UNITED STATES PATENT AND TRADEMARK OFFICE

APPLICATION NO.	FILING DATE	FIRST NAMED INVENTOR	ATTORNEY DOCKET NO.	CONFIRMATION NO.
10/061,458	02/01/2002	Linh A. Dinh	S63.2-10389	9614
490	7590	08/30/2005	EXAMINER	
VIDAS, ARRETT & STEINKRAUS, P.A. 6109 BLUE CIRCLE DRIVE SUITE 2000 MINNETONKA, MN 55343-9185			STEWART, ALVIN J	
			ART UNIT	PAPER NUMBER
			3738

Office Action Summary

10/061,458

(54) STENT WITH REINFORCED STRUTS AND BIMODAL DEPLOYMENT

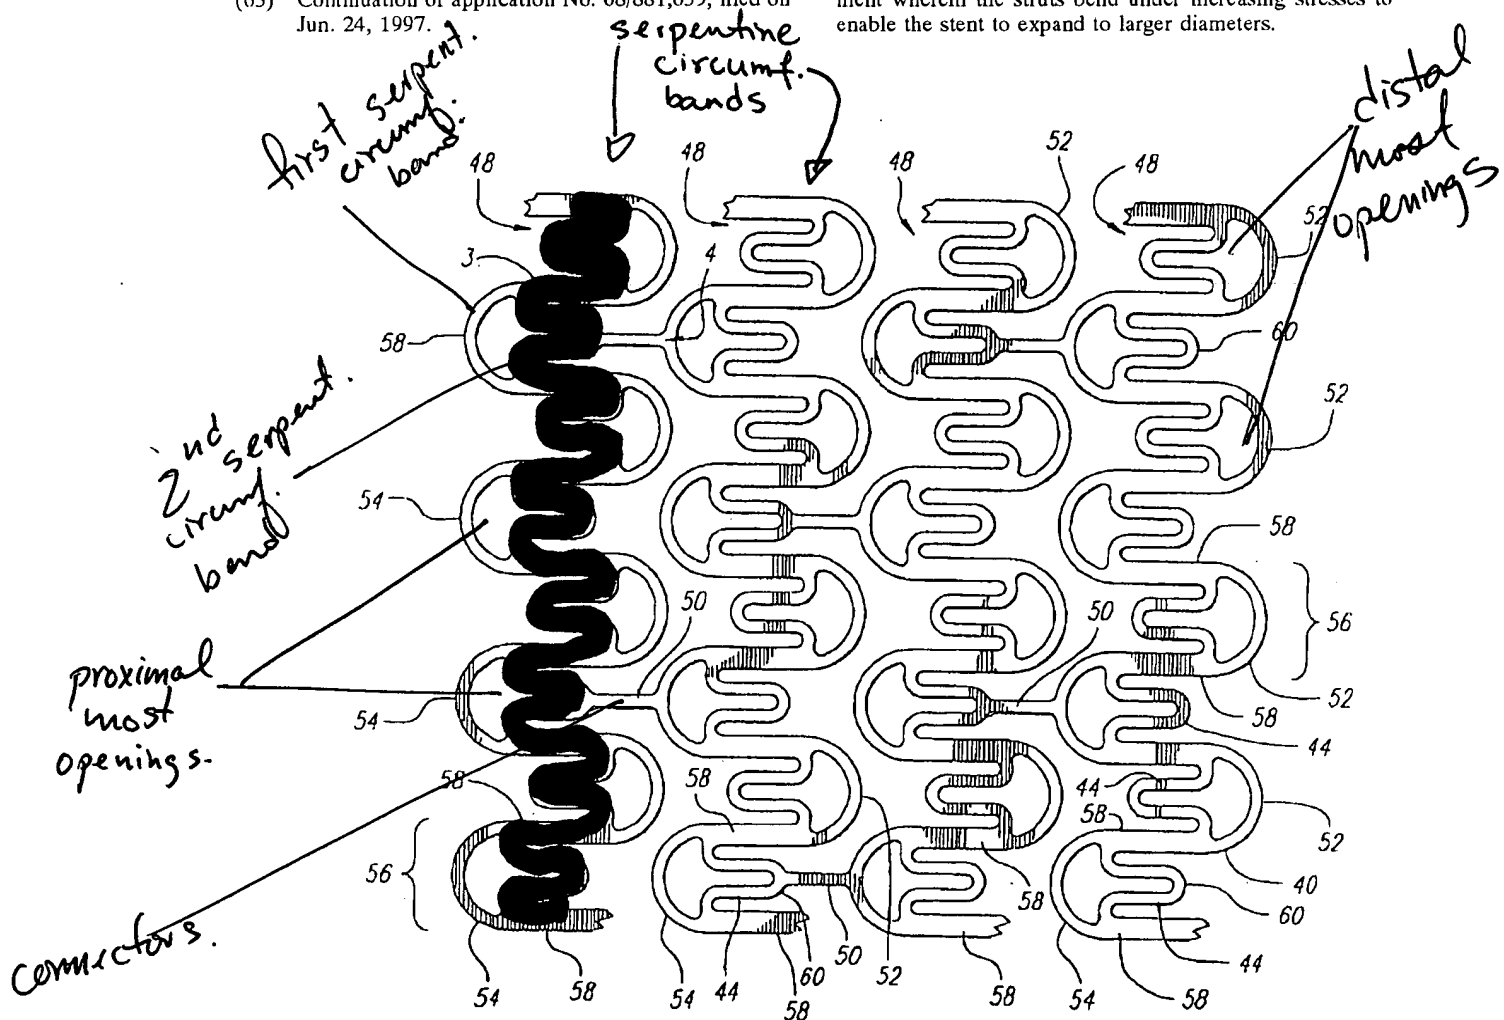
Regarding claims 16, 17, 20, and 22, see attachment A.

Attachment B

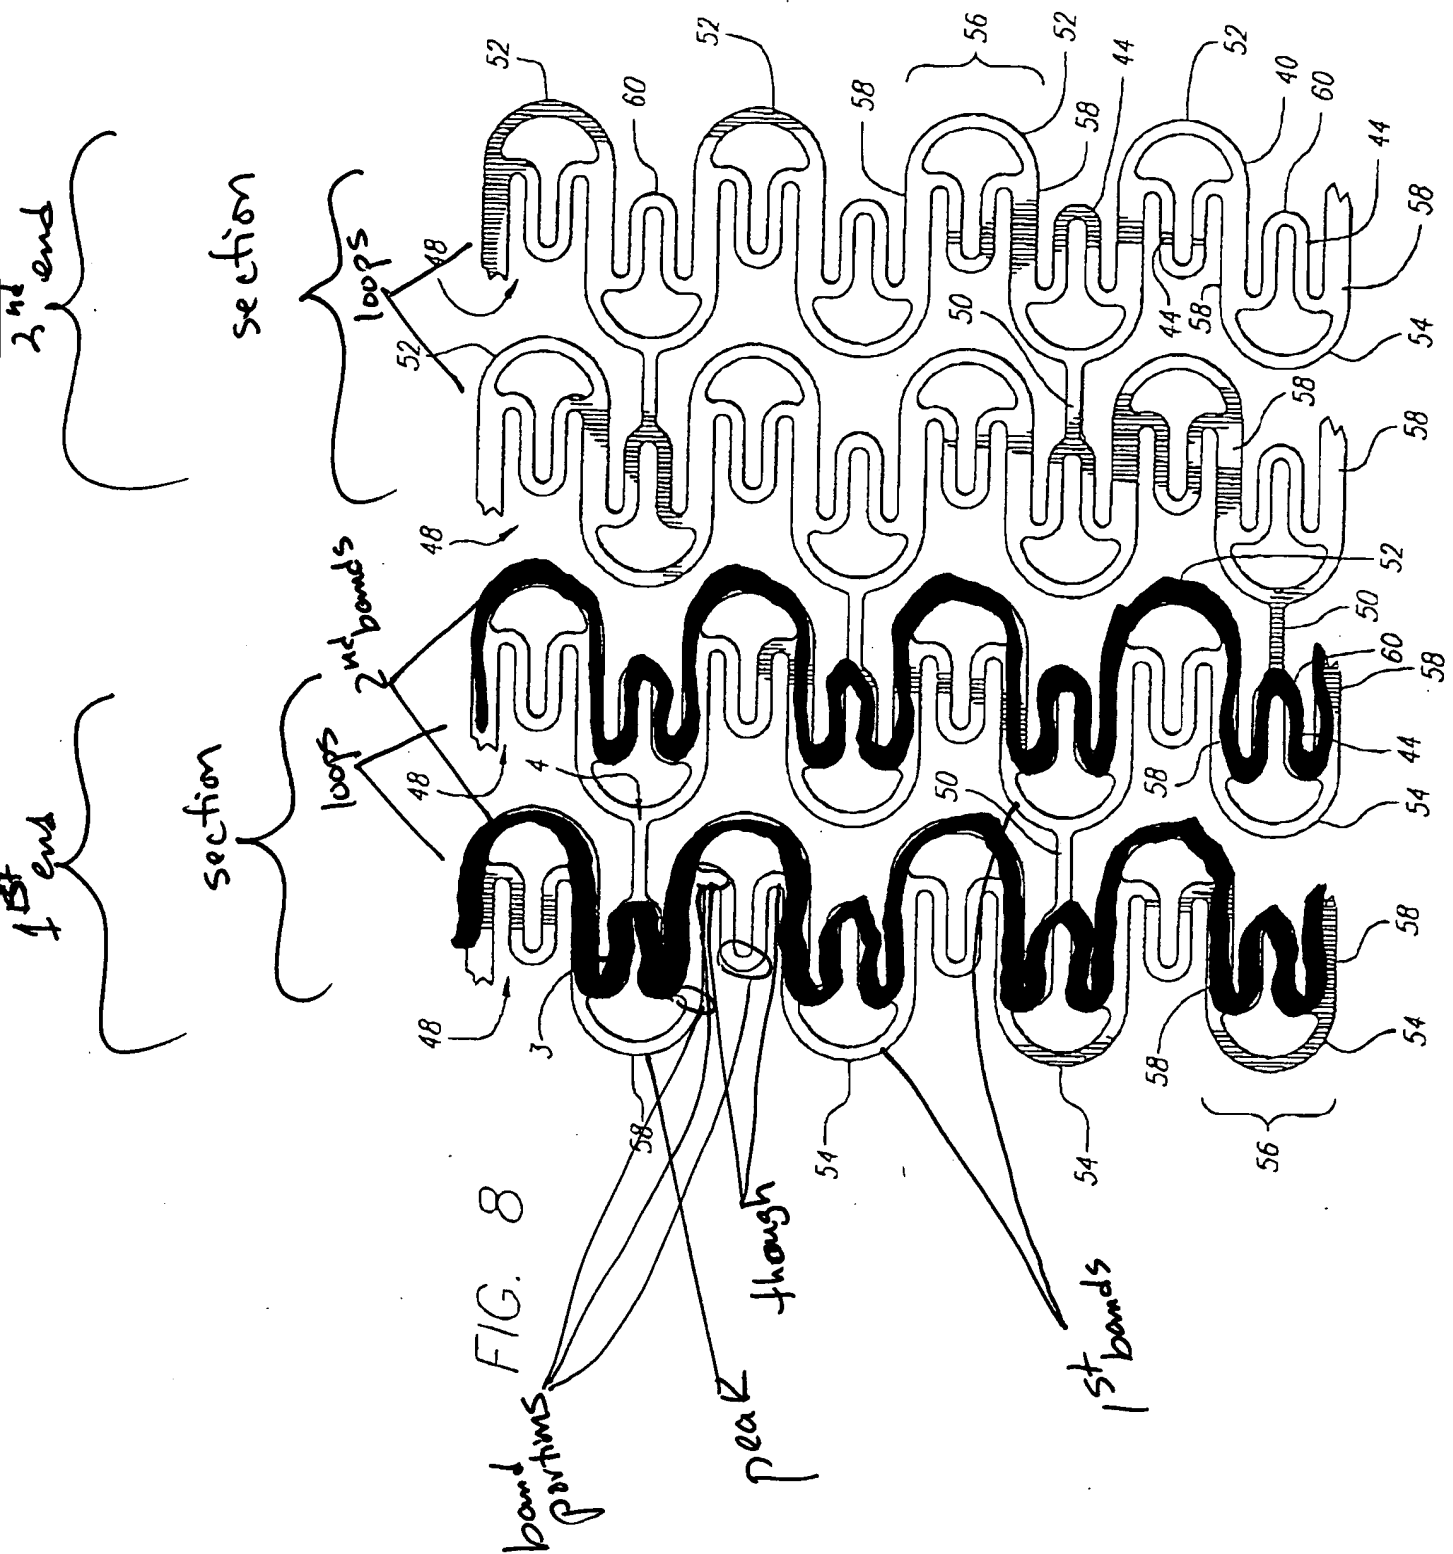
Regarding claims 25-27, see attachment B.
